UNITED STATES PATENT AND TRADEMARK OFFICE

APPLICATION NO.	FILING DATE	FIRST NAMED INVENTOR	ATTORNEY DOCKET NO.	CONFIRMATION NO.
09/665,668	09/20/2000	Larry B. Gray	JJI-49	5527
7590 03/18/2009 Audley A. Ciamporcero, Jr., Esq. Johnson & Johnson One Johnson & Johnson Plaza New Brunswick, NJ 08933-7003			EXAMINER BUI, VY Q	
			ART UNIT 3773	PAPER NUMBER
			MAIL DATE 03/18/2009	DELIVERY MODE PAPER

Office Action Summary**Application No.**

DETAILED ACTION

FIG. 2

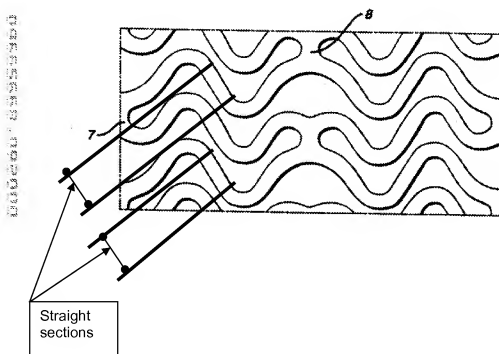
At least Kleshinski-'765's stent 14 includes curved section where struts 6 are bent around pins 50 (Fig. 13). It is clearly shown in Fig. 13 that Kleshinski-'765's stent 14 includes straight sections where struts 6 abut each other along a distance between two pins 50. However, Fig. 2 and 6 (Fig. 2 is reproduced below) of the present invention also show curved

and straight sections, therefore the stent of the present invention includes curved and straight sections as well as Kleshinski-'765's stent 14.

1. This newly added limitation was simply not in the original written specification.
2. Even in Fig. 2 and 6 as mentioned by the Applicant, there are straight sections in the structure of the stent of the present invention. Fig. 2 and 6 are indeed support that waves in this present invention will include curves and straight sections (see for example: Figs. 2, 4, 6 and 7 with curved and straight sections).
